G.O., No. 1250 I., 15th December 1905.

Periyar-affected tanks in the Melur Taluk, Madura District

NOTES CONNECTED WITH G.O., No. 1250 I., DATED 15TH DECEMBER 1905.

[SUBJECT.—*Tanks proposed to be retained in the Periyár-affected part of the Mélúr taluk.*]

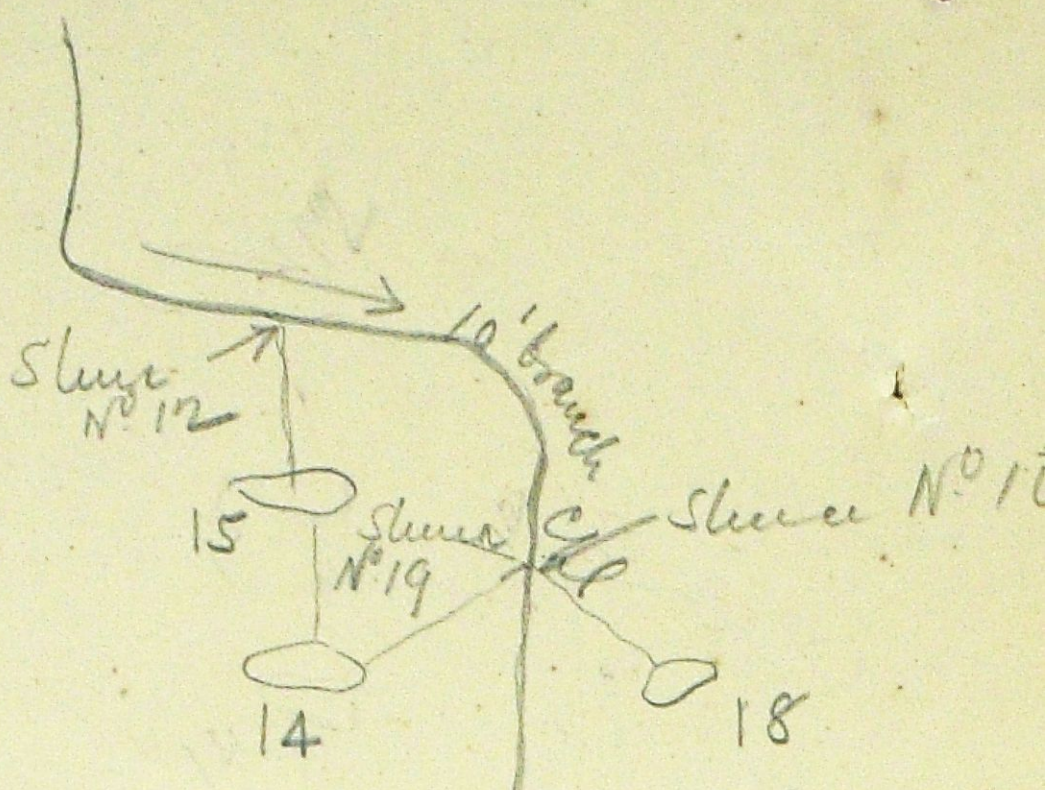
from sluices Nos 12 & 10
respectively; but ~~the tracing~~ the state-
ment is not reconcilable
~~indicates that the sluices~~
with the positions of
~~No 19 & 10 are built at one~~
the tanks on tracing
~~and the same point~~
unless the numbering
~~but on opposite banks of~~
of the sluices is
~~the 10' branch channel~~
not consecutive as
~~about a mile & half~~
it ought to be"
~~below the sluice No 12~~
~~supplying tank No 15.~~

~~It is not understood
why the sluices referred to
have not been numbered
according to their positions
with reference to mileage.~~

~~(3)~~ (2) Tanks Nos 38 & 39 are
shown in the tracing as
lying in Madura taluk
but according to the taluk
map of Melur, they belong to
the latter taluk.

No sluices shown on tracing
